To: Lafayette County Planning Commission
From: Tristan Riddell, Planner
Meeting Date: October 26, 2026
Case: 26-317

Applicant: Magnolia Materials, LLC
Request: Final Site Plan

**RE: Final Site Plan Submittal – Changes Summary
Magnolia Materials Hot Mix Asphalt Batch Plant
Lafayette County, MS**

SITE PLAN & CONSTRUCTION PLANS
FOR
MAGNOLIA MATERIALS
(HOT MIX ASPHALT BATCH PLANT)

DIVISION OF ENGINEERING
SITE PLAN – ASPHALT PLANT LAYOUT
LAFAYETTE COUNTY, MS

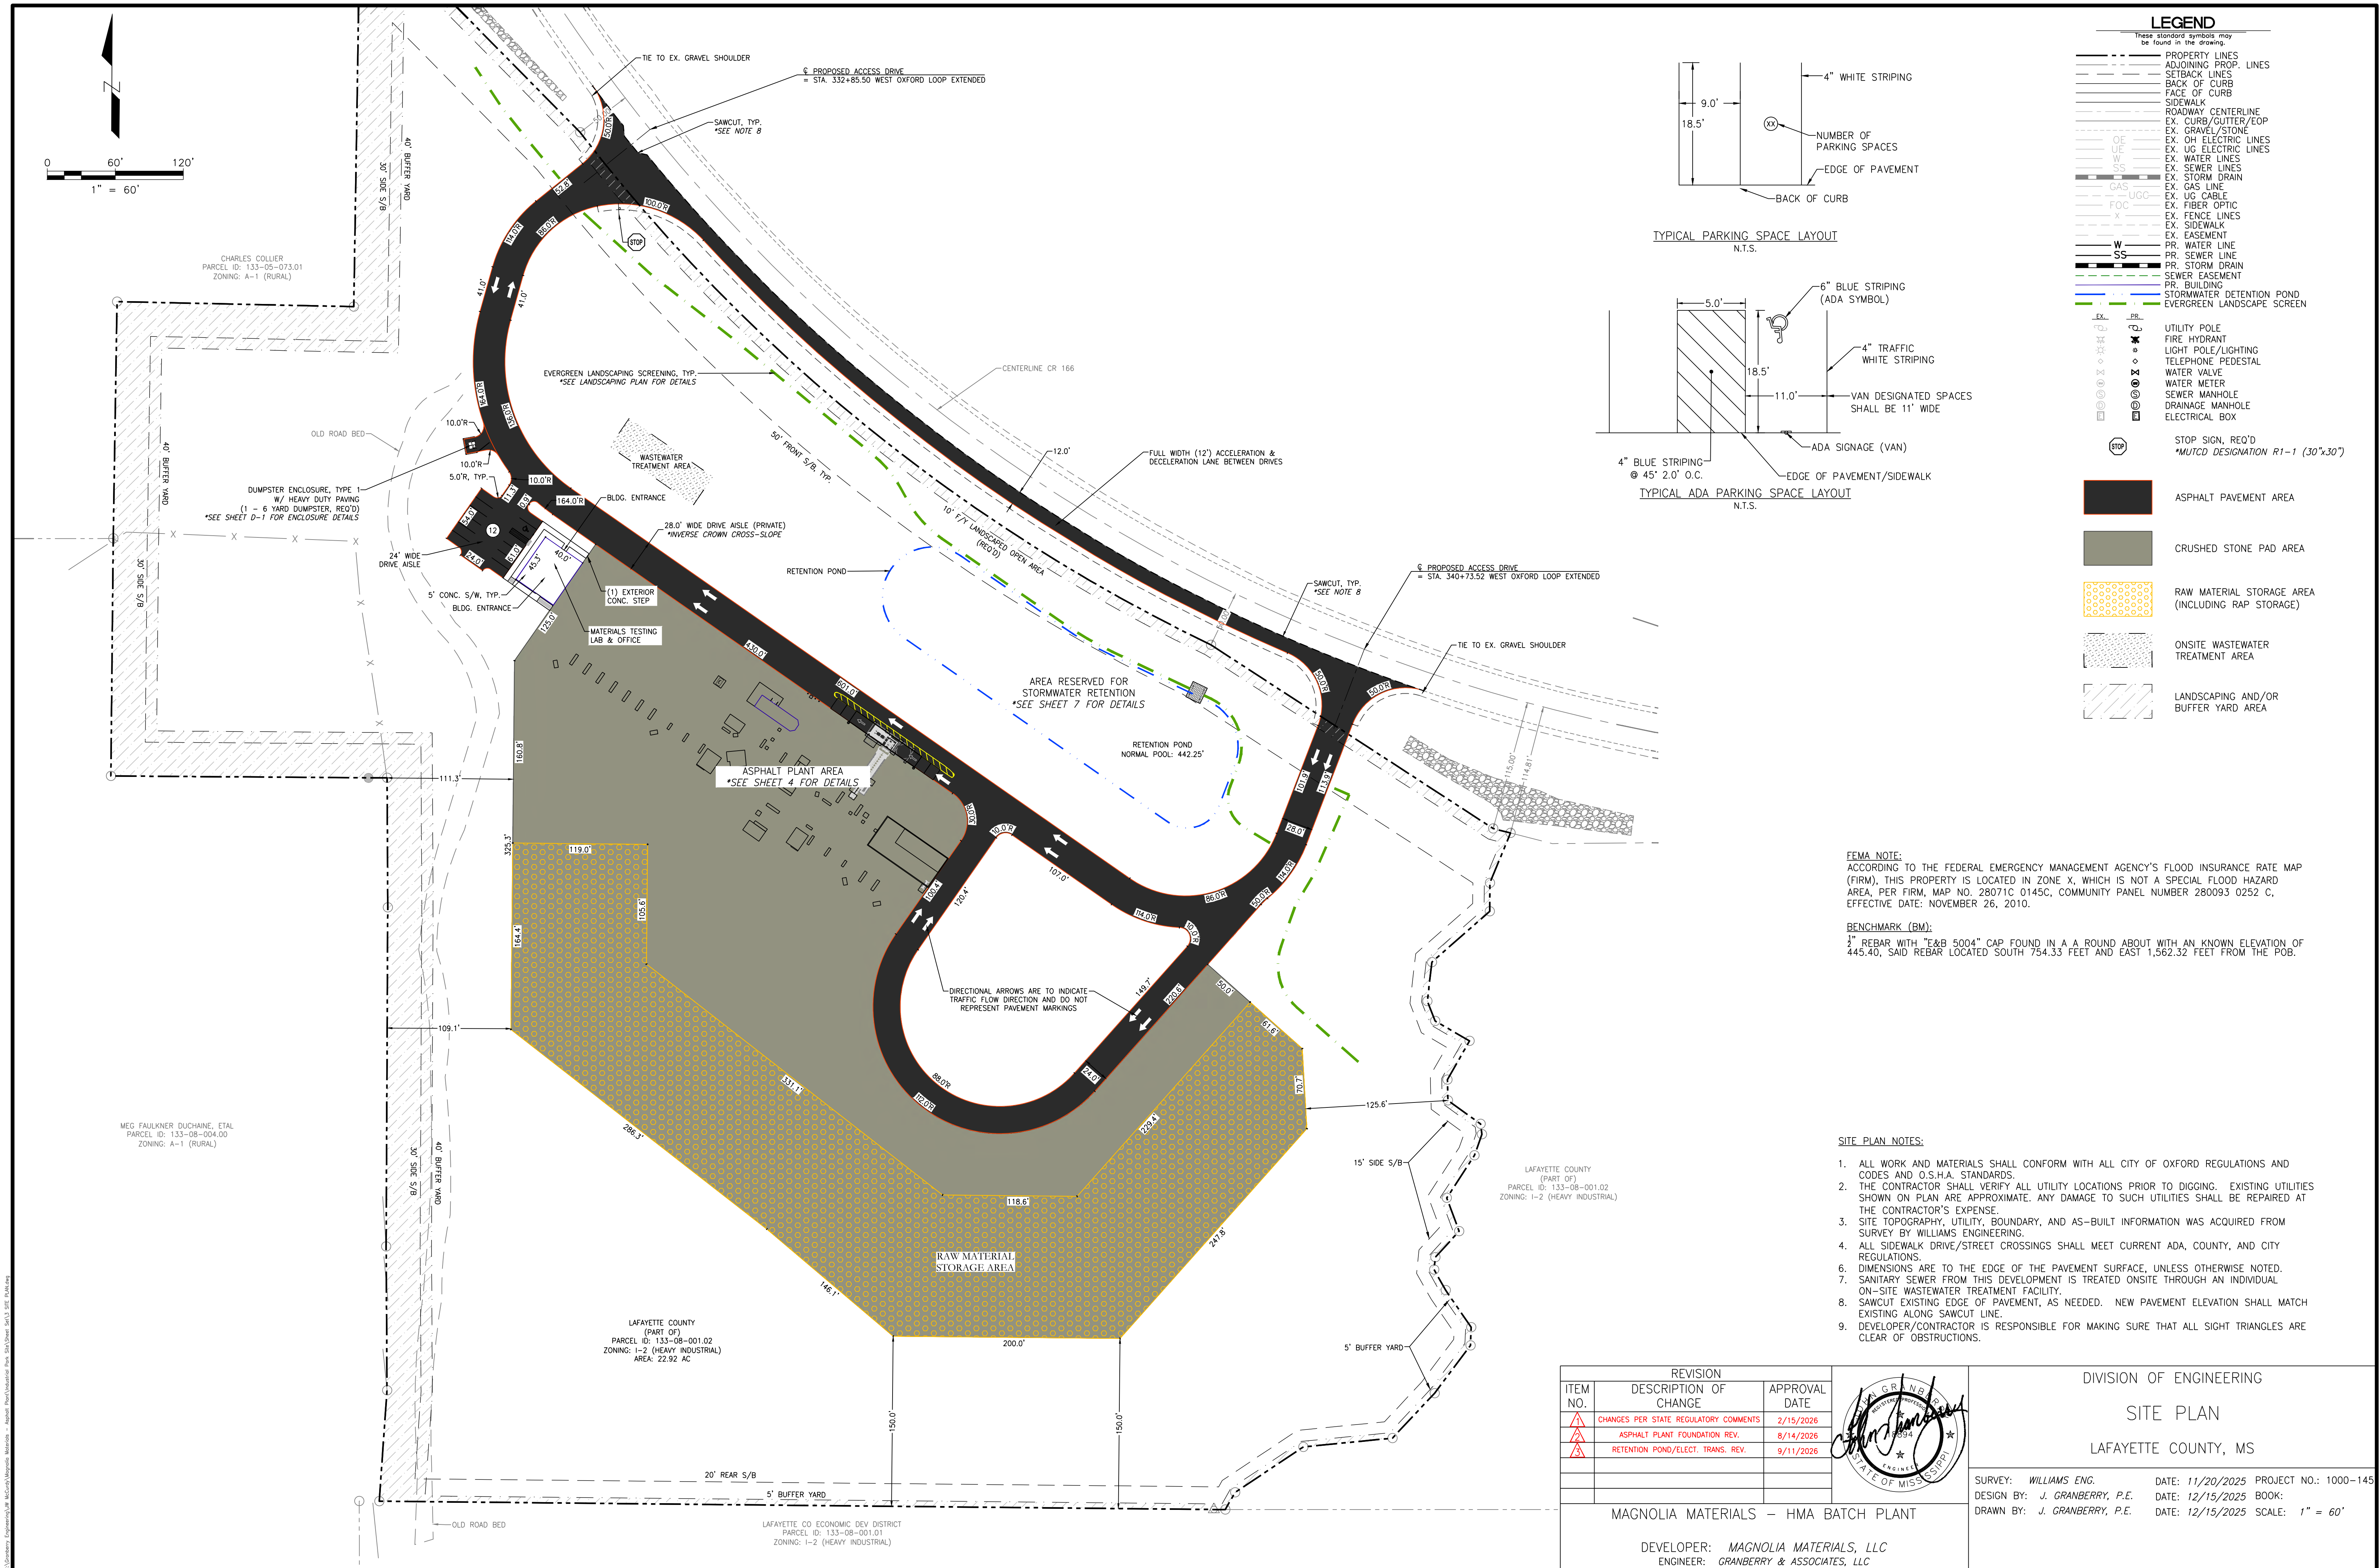
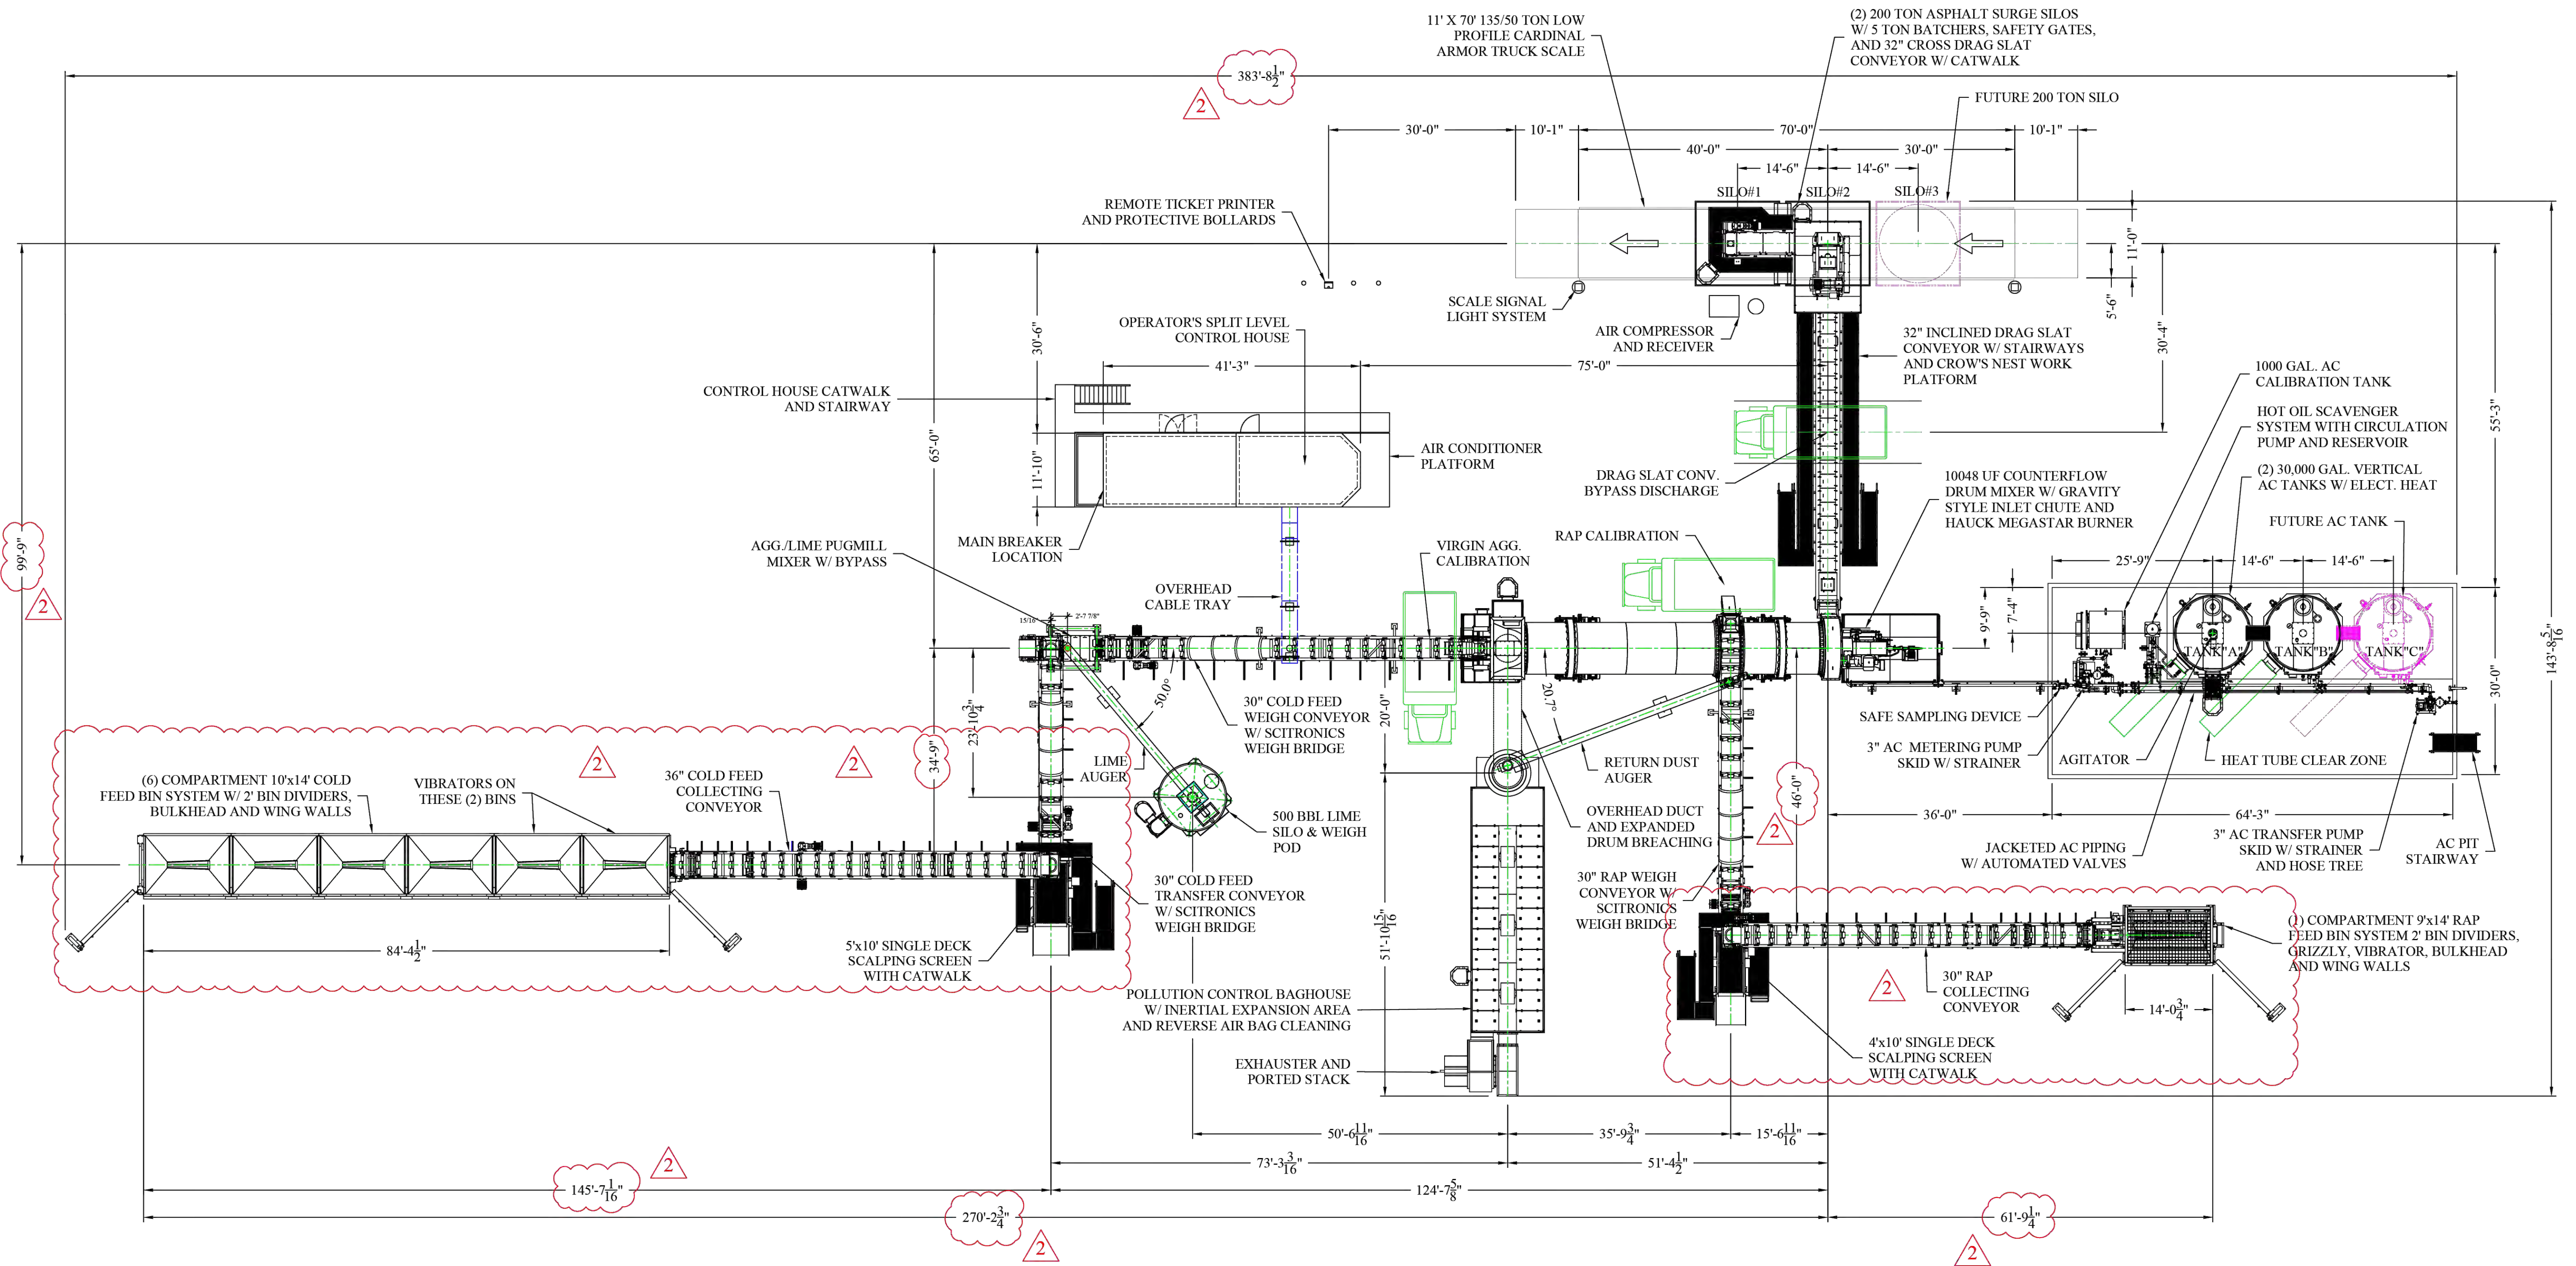
- A clay liner was added to the retention pond to prevent stormwater from percolating into the groundwater.
- The layout and grading of the asphalt plant and scale areas were revised to accommodate updated requirements from the asphalt plant manufacturer.
